**Report on the Tolerance Analysis of ETM Telescope for California Institute of Technology**

To evaluate the tolerances provided by California Inst. of Tech. and to recommend optimized tolerances for the ETM telescope.

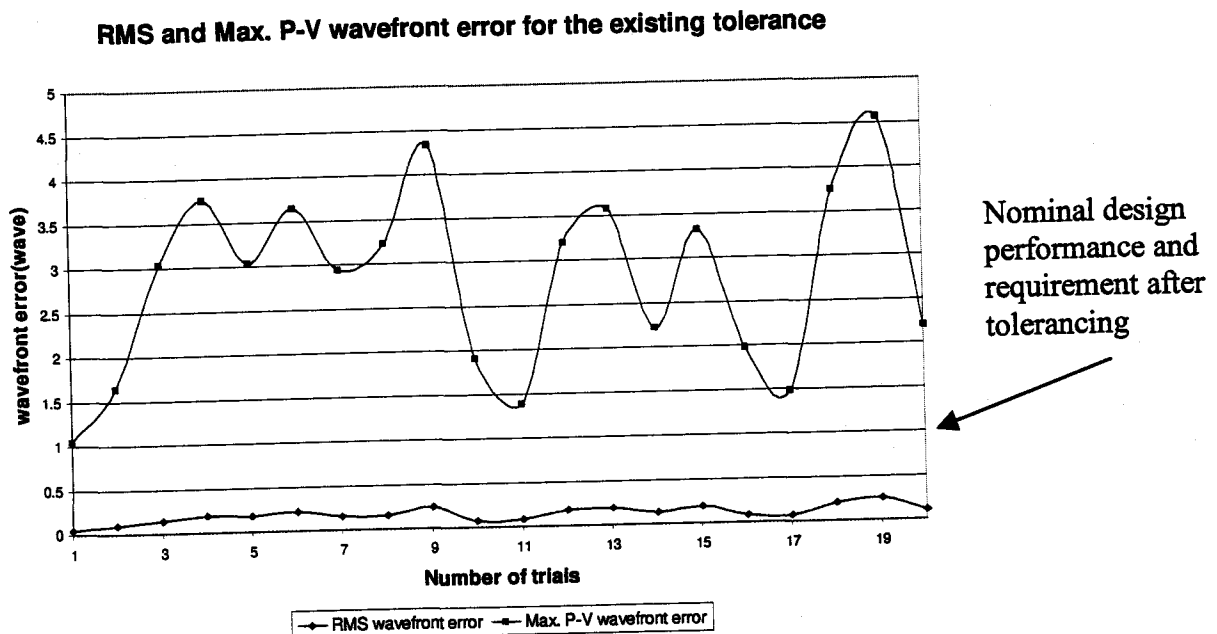
The following figure shows the RMS wavefront error and maximum P-V wavefront error of the 20 Monte Carlo runs based on the existing tolerances. The maximum P-V wavefront error is 4.5666 wave.

It shows that the P-V wavefront error with the existing tolerances is far larger than 1 wave which is specified in the statement of work.

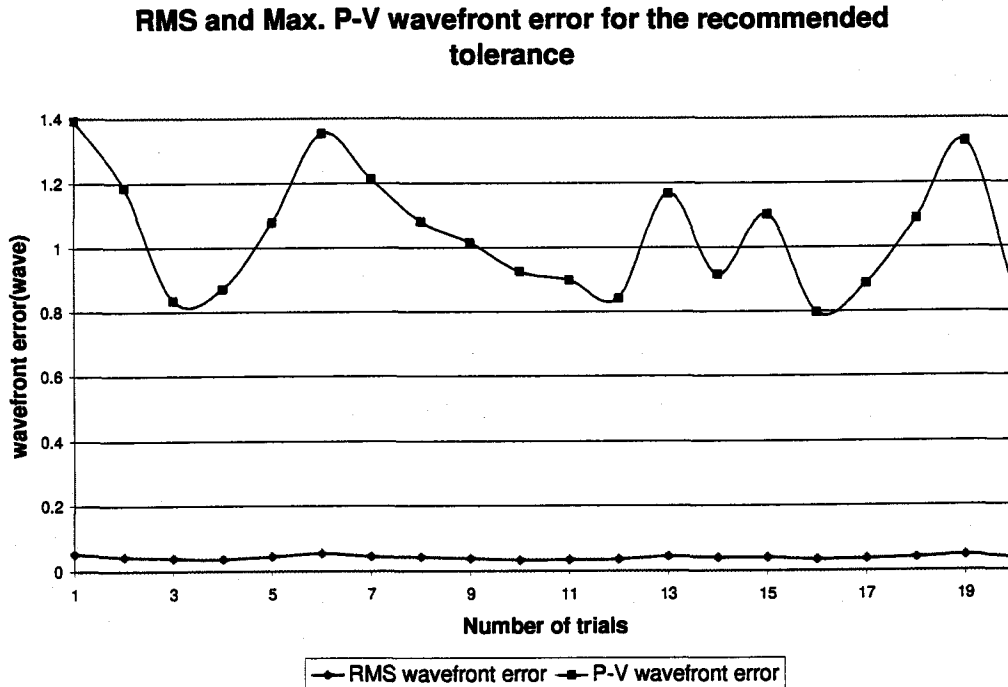
The following figure shows the RMS and maximum P-V wavefront error of the 20 Monte Carlo runs with the recommended tolerances. The maximum P-V wavefront error is 1.3949 wave.
